### **Manor House Farm, Barn**

In response to the latest queries raised by Building Conservation I would like to confirm the following:

Proposed Re-construction & Alterations to Existing Barn  
At Manor House Farm, Troutsdale, Scarborough  
For: Mr. J Guthrie

Stone Barn - ground floor layout as proposed

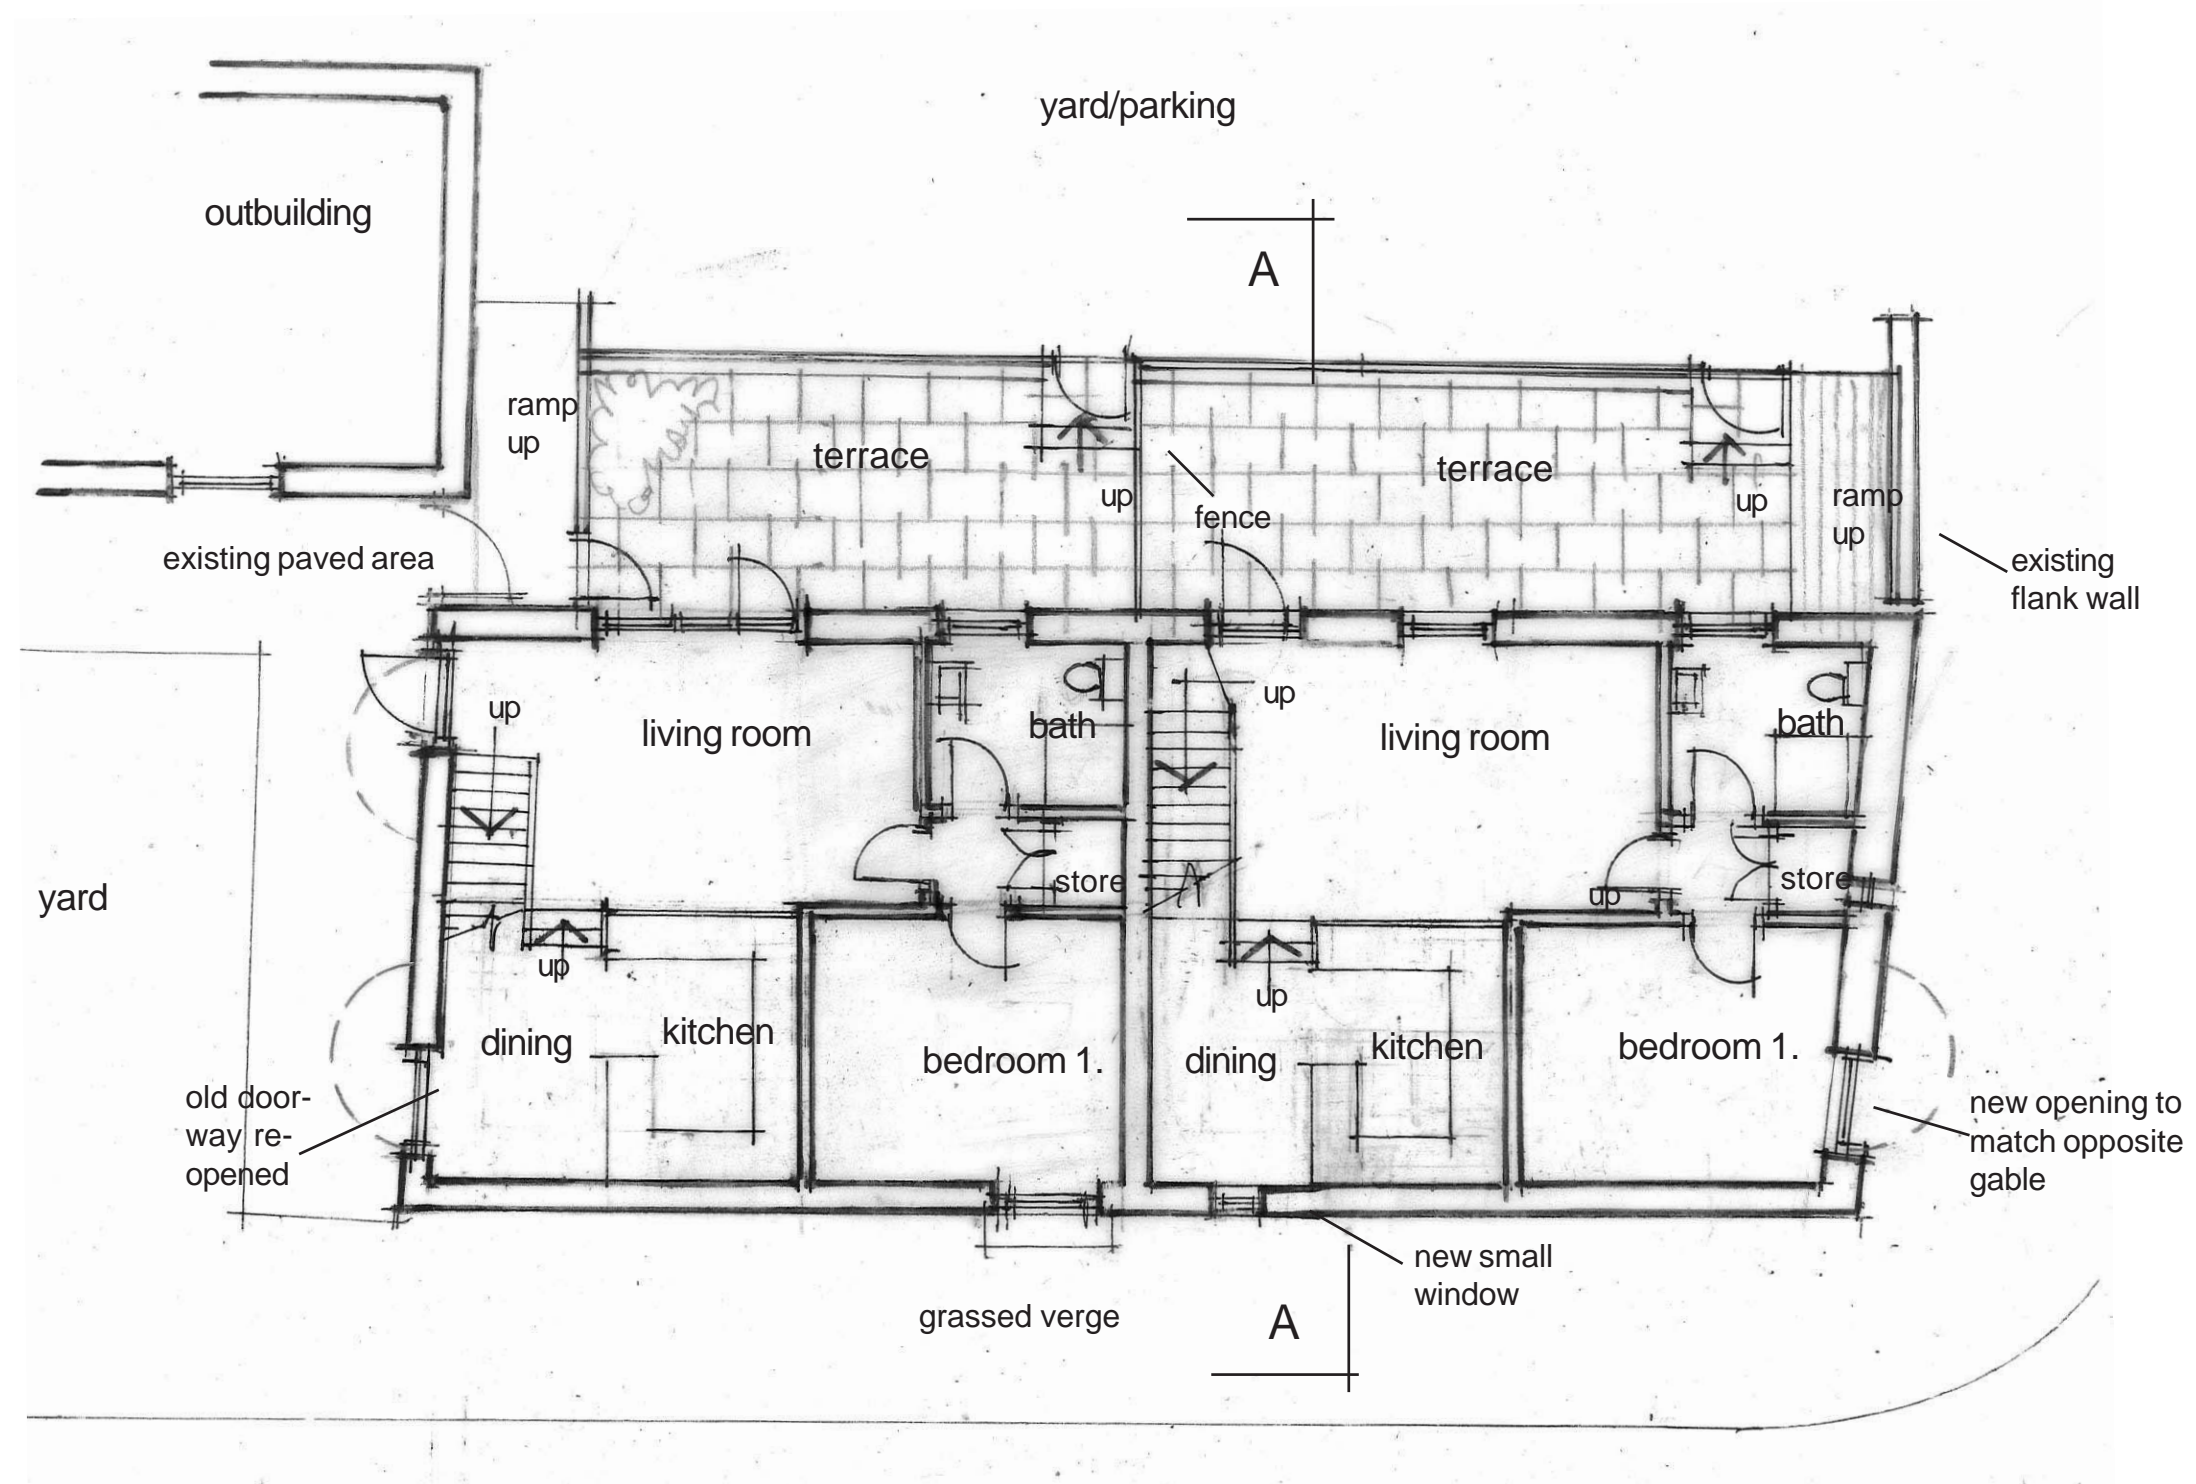
5. The intention with the terrace areas and steps would be to use yorkstone slabs with some planted areas. The yard is cut into the slope of the ground so would require a small retaining wall Where the steps and ramp up are needed – we could either plant a hedge across this change in level or have a timber fence to afford some privacy to the yard areas. A fence might be more appropriate for the ex-farmyard setting?

6. Windows – the preference is for some glazing bars to avoid the building looking too stark, so the proposal has been revised to casements with 3 top panels. We would certainly intend to paint these in a dark colour to avoid the windows being too prominent. For consistency nearly all windows have been changed to a 3 over 1 configuration.

Rev A - various changes July '23  
Rev B - door/window revisions Aug '23.  
Rev C - stairs revised Sept '23  
Rev S - terrace & window rev. Sept '23

Stone Barn - Elevations as Proposed 1.

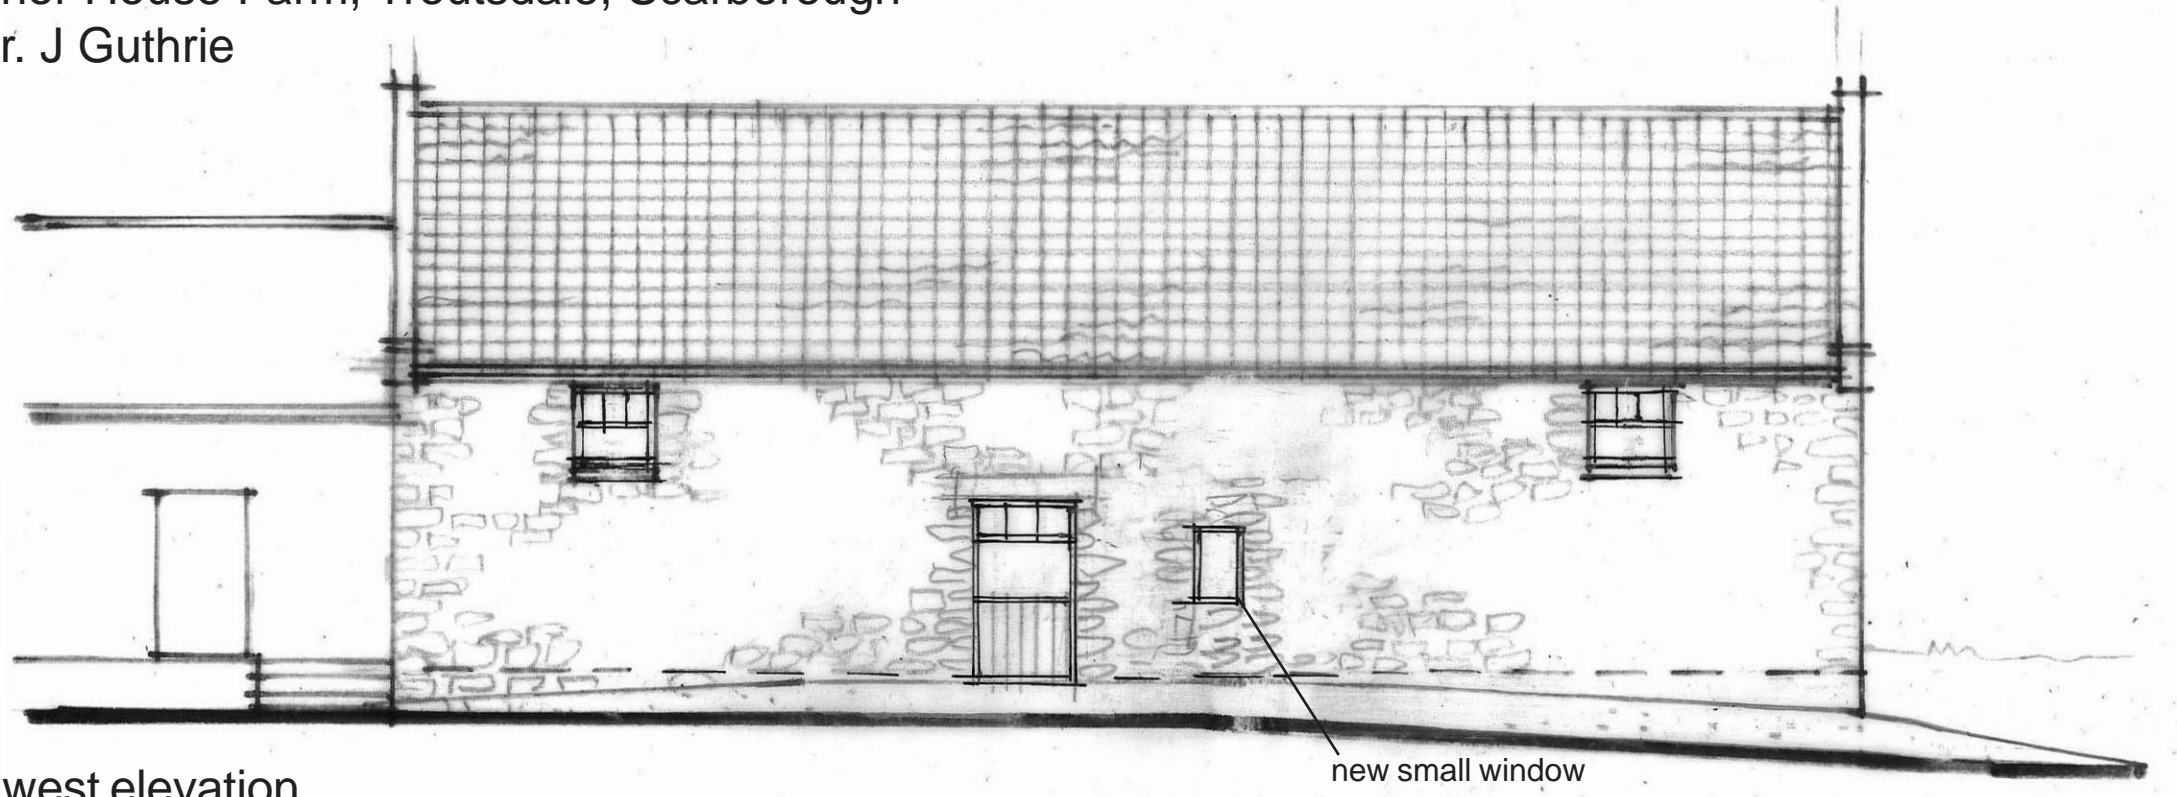
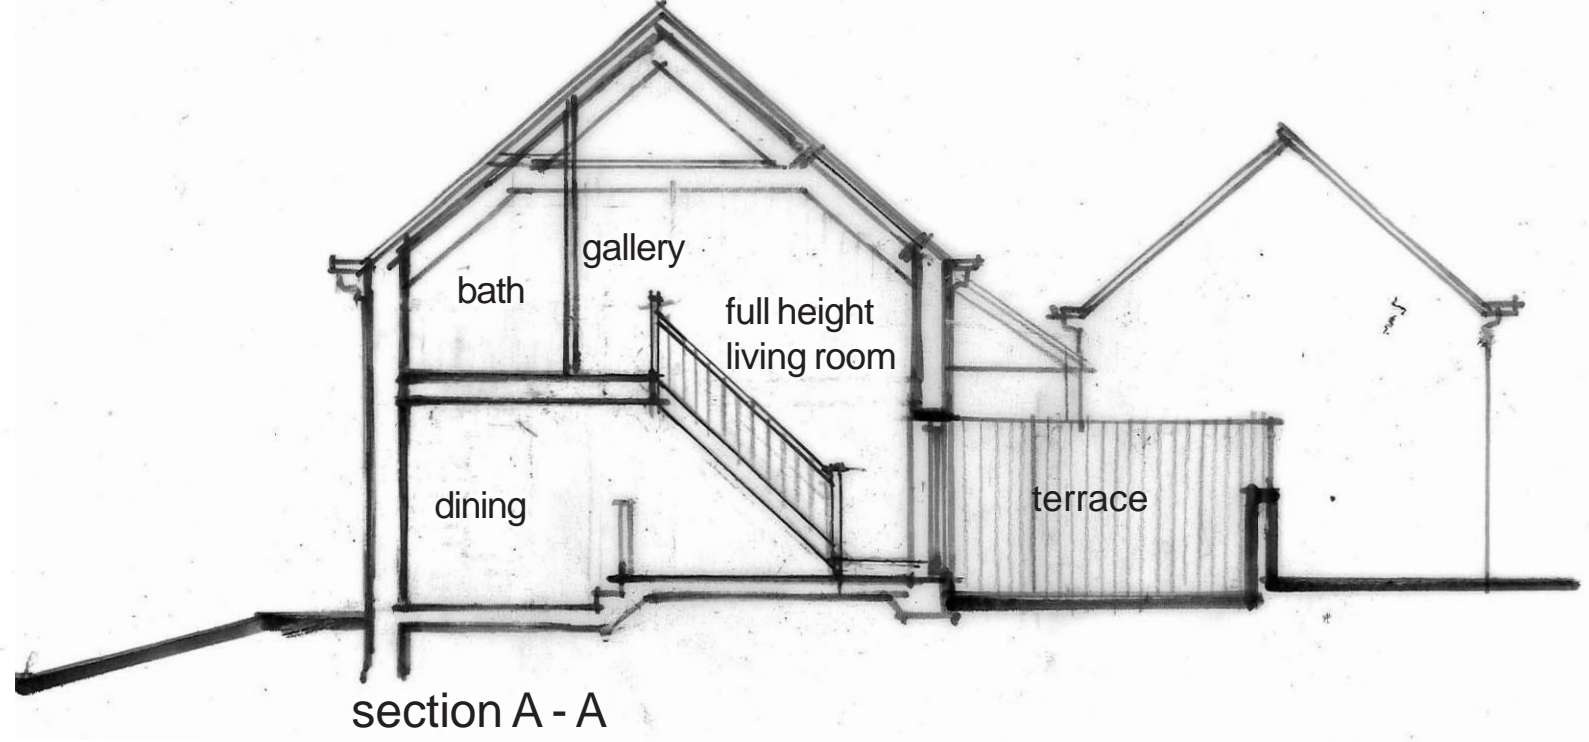
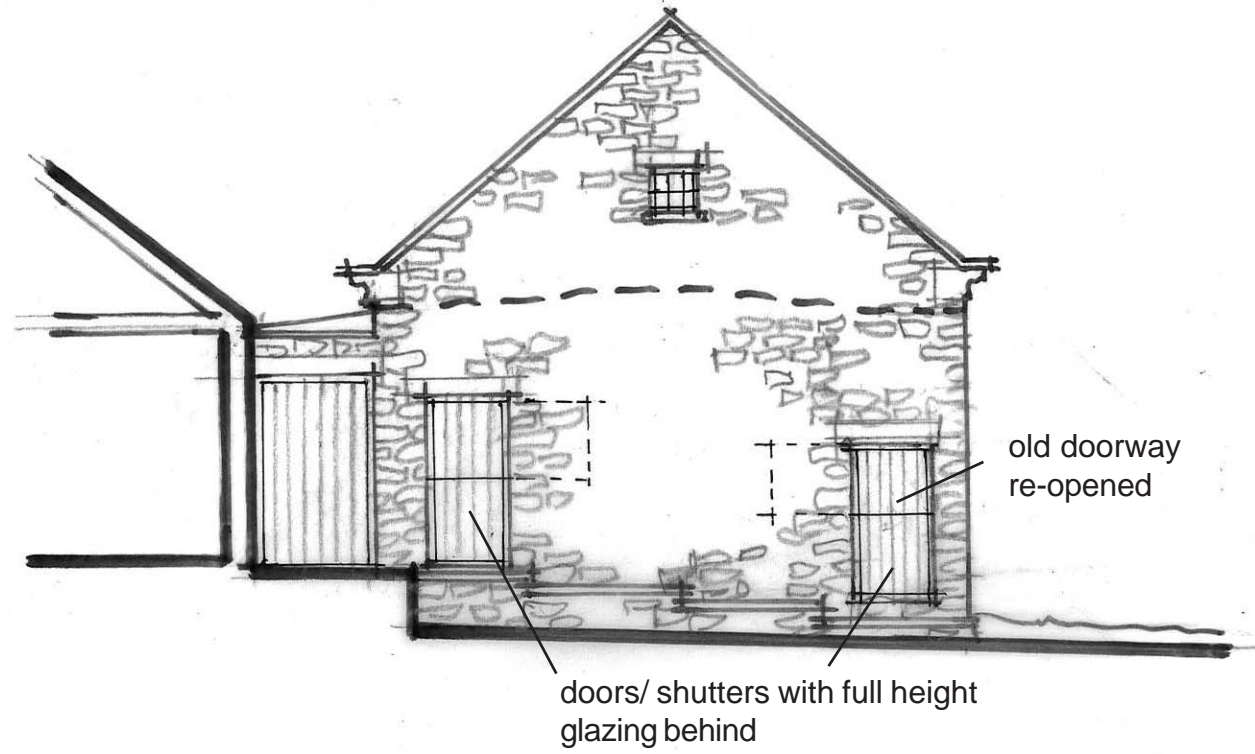
3. Mea culpa – the drawing for the south elevation on the submitted plans was wrong as, for some obscure reason, the north elevation was duplicated! This has been corrected and the plan and elevations now correspond. The upper floor window referred to does not change and remains as existing.

7. I am disappointed by the suggestion of reducing the size of the one new window on the west elevation but will do so. We need some light in this part of the building and the smaller window is not really enough – but so be it.

Rev A - door/window revisions Aug. '23  
Rev B - elevations revised - Oct '23

North Elevation

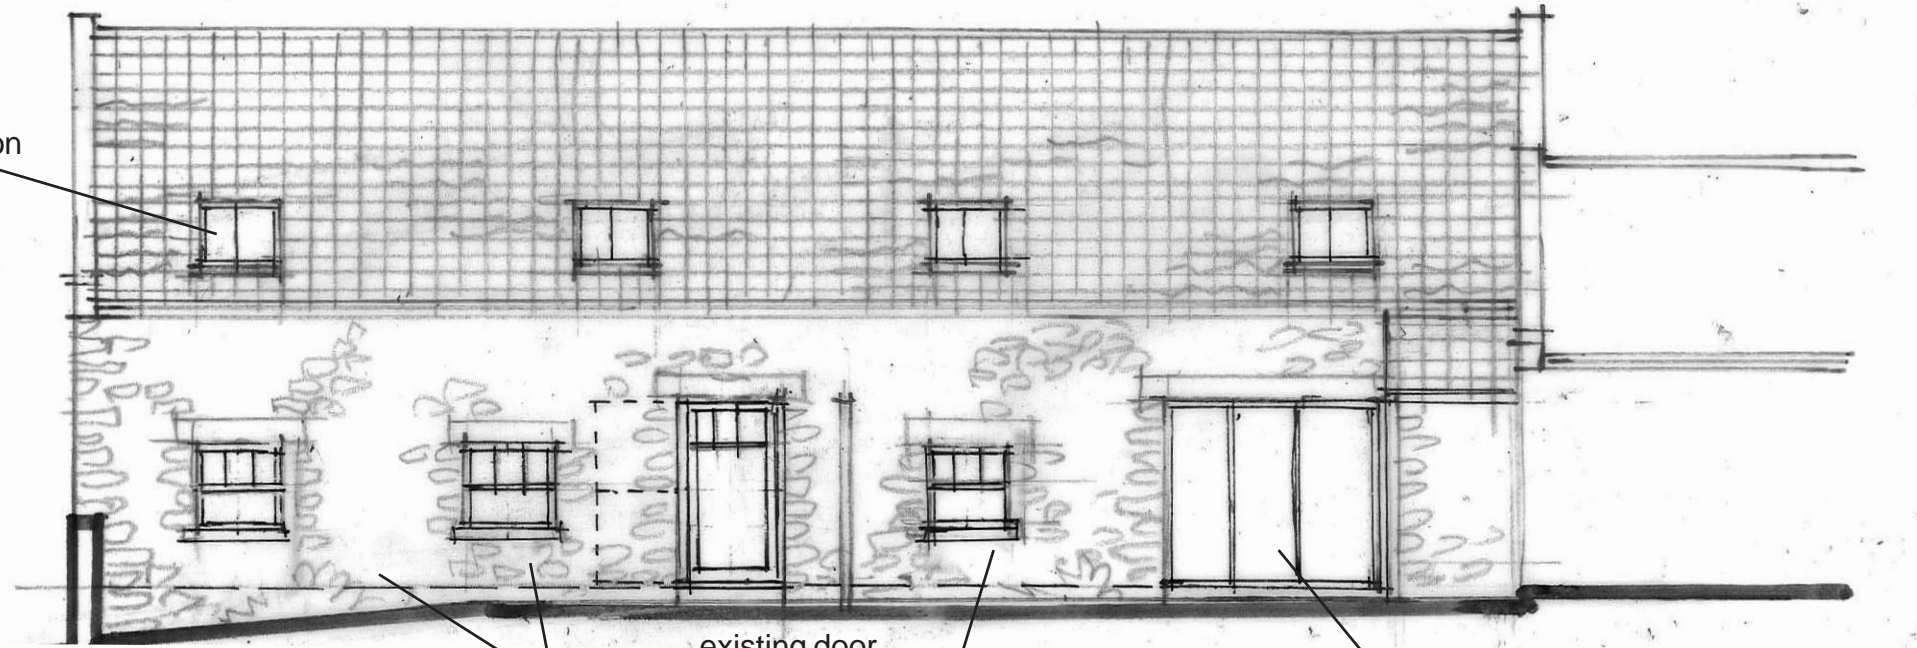
2. Shutters – we are of the opinion that the shutters were a good addition to the barn as, when it is all closed up it would look more “barnlike”. However we have no strong feelings on this and could remove them – a useful economy? The “shutters” would only be on the door sized openings and I do not agree that they would look cluttered – they would look like a farm building? The drawings show the shutters open on the north side and closed on the south to show how the alternatives would look.

Rev A - door/window revisions Aug. '23  
Rev B - windows revised Sept '23
